PROJECT/SITE OWNER: Bayside Development Partners II, LLC PROJECT ADDRESS: 600 Block of West Glencoe Place	PROJECT SUMMARY: New mixed occupancy 5 story building
--	---

VILLAGE CODE REVIEW

Date: November 4, 2022
To: Village of Bayside
From: Jackie Mich, AICP; Jeff Maloney; and Dean Proctor, AIA
Re: Building C – Architectural Review Committee Submittal

ONE NORTH - MULTIFAMILY BUILDING C

SHEET:
**OVERALL SITE
LANDSCAPE PLAN**

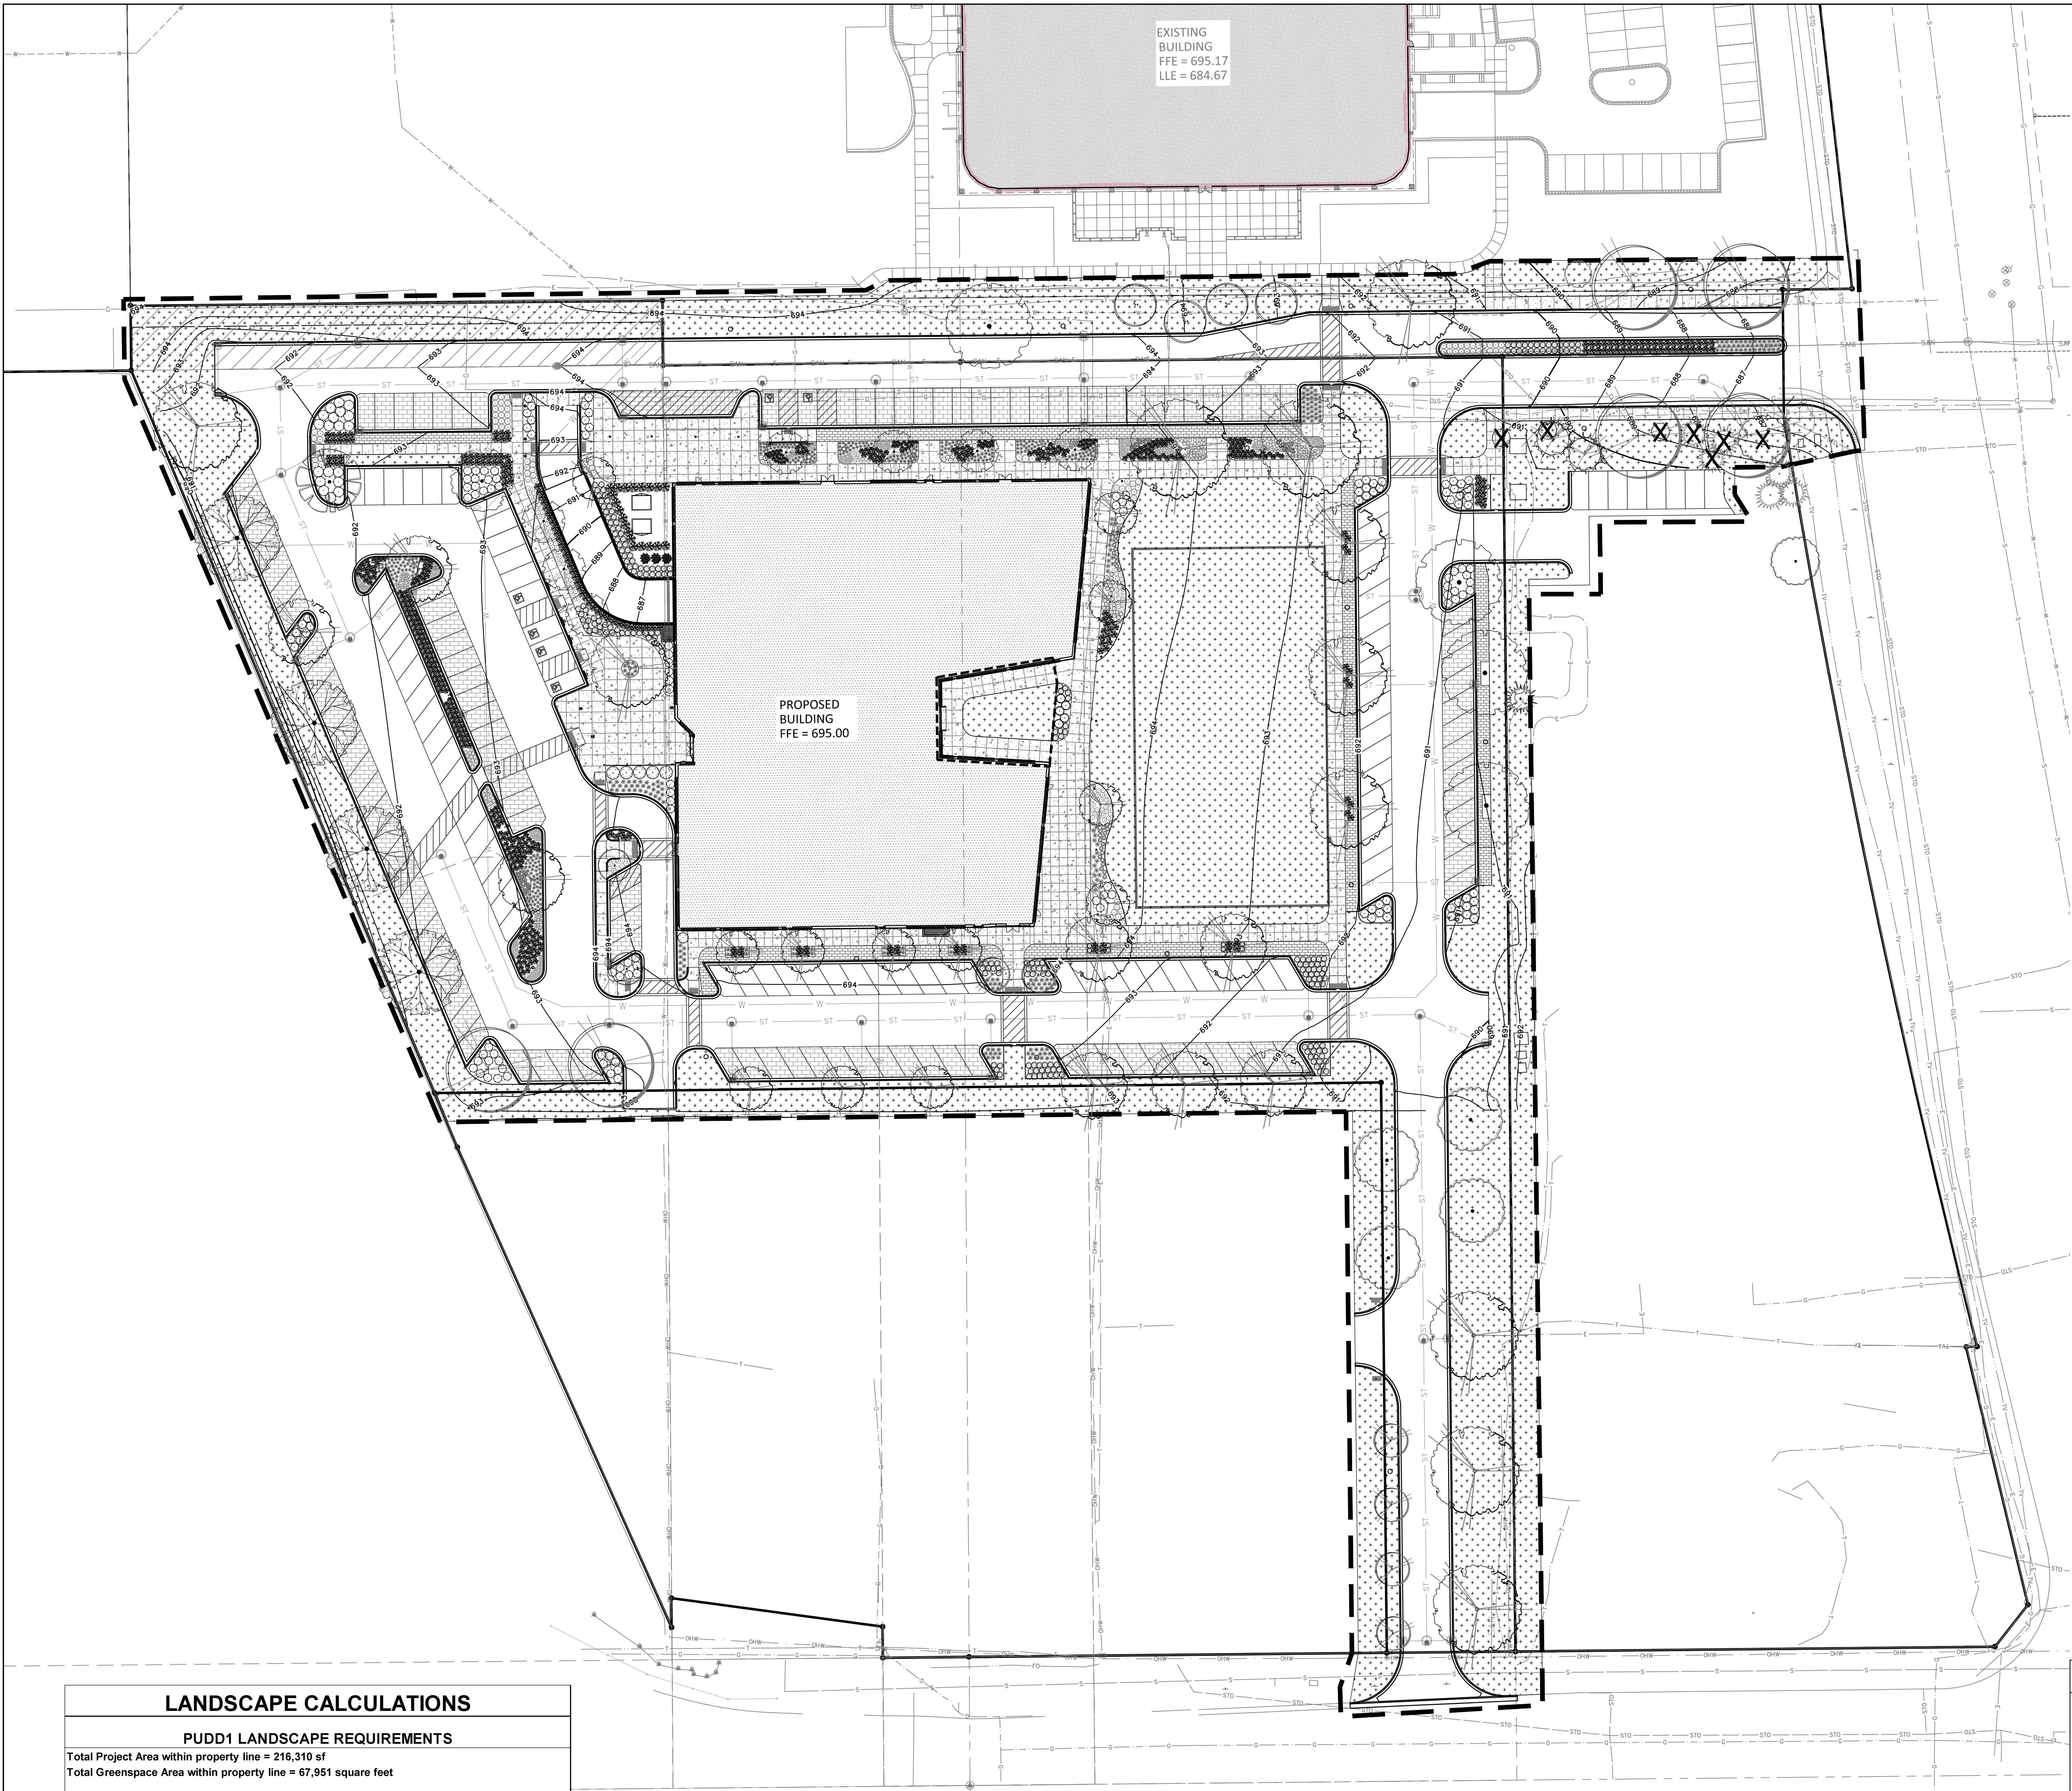
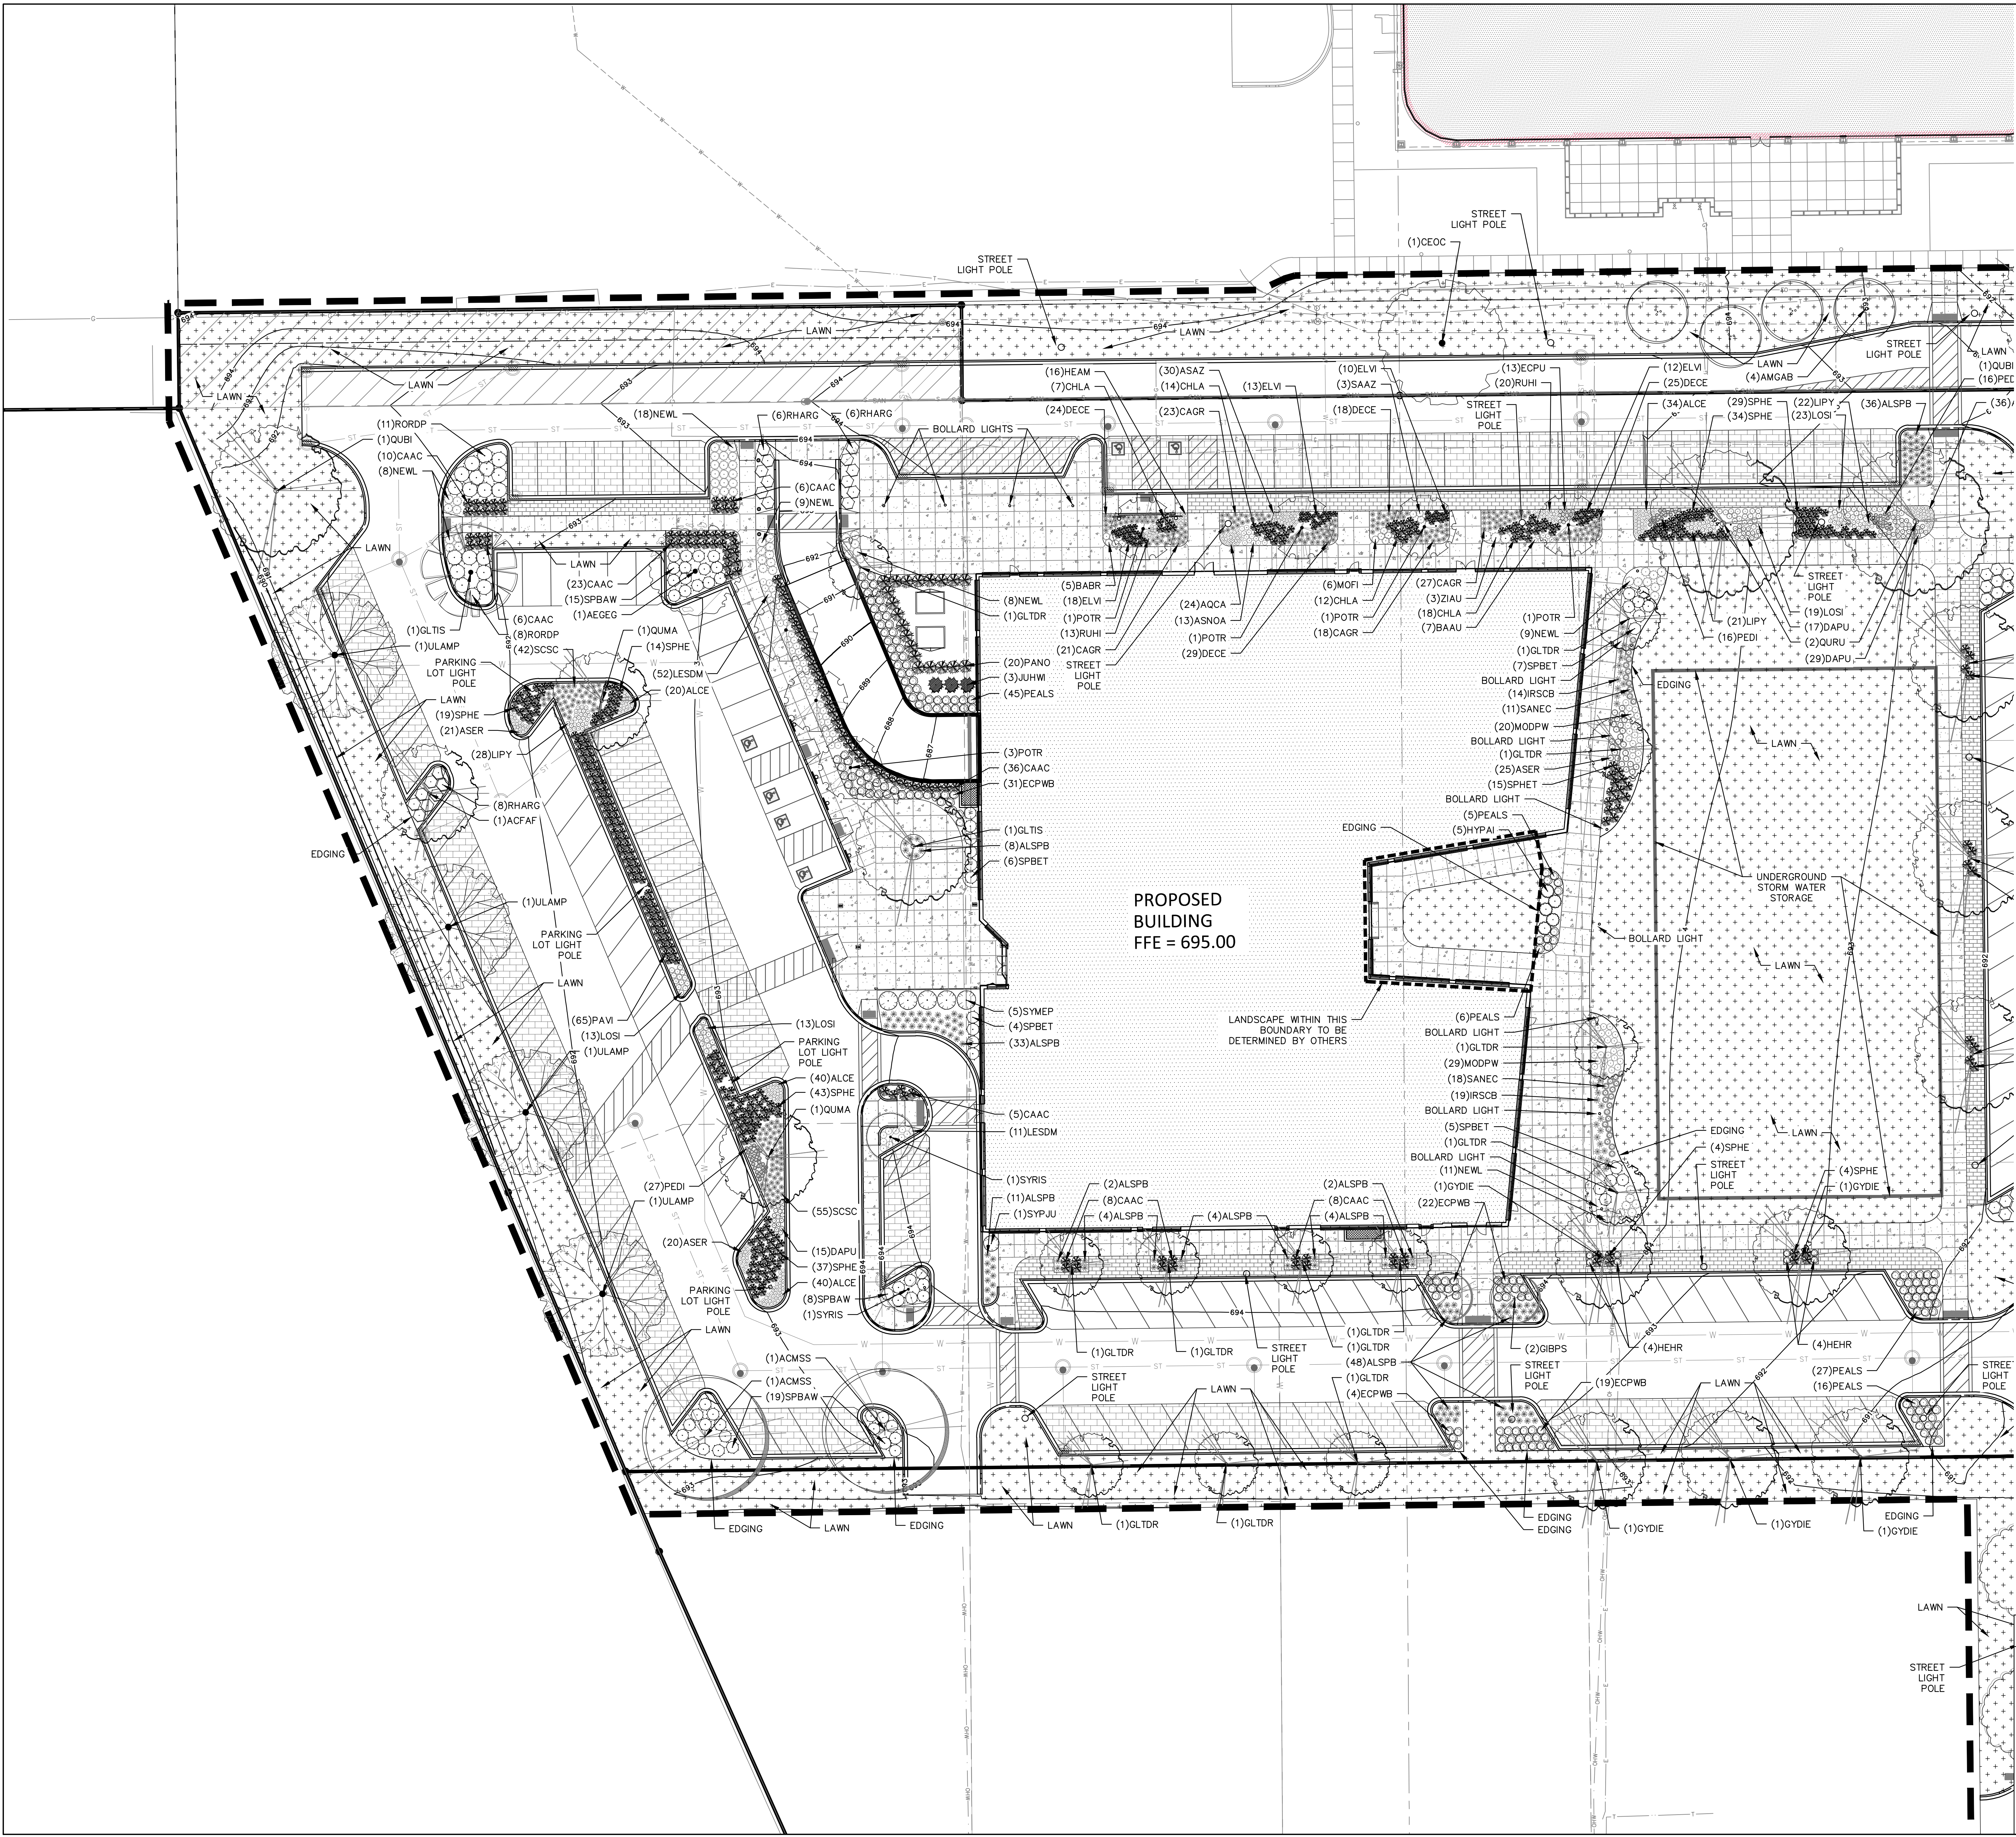
Plants located on the north side of building will generally be shaded by the five-story building, which affects selection of plant species. Vandewalle staff offers the following notes on plantings located on the north side of the building:

- Quaking Aspen needs four hours of direct sunlight daily. If not provided, consider a more shade-tolerant species.
- Morning Star Sedge prefers direct sunlight. May not grow successfully in shade.
- Black Eye Susan prefers direct sunlight. May not grow successfully or flower in shade.
- Cream and Blue False Indigo may not flower in shade.
- Tufted Hair Grass may not flower/seed in shade.
- Sky Blue and New England Aster may flop in shade.
- Blue Sage prefers some direct sun daily.

A final note is that “Native Mix 1” is noted in the legend but not shown on the plan.

6. Use shade-tolerant plant species on the north side of the building, as described on page 4 of this report.
7. Add a canopy over the library entry area and drive-through window.
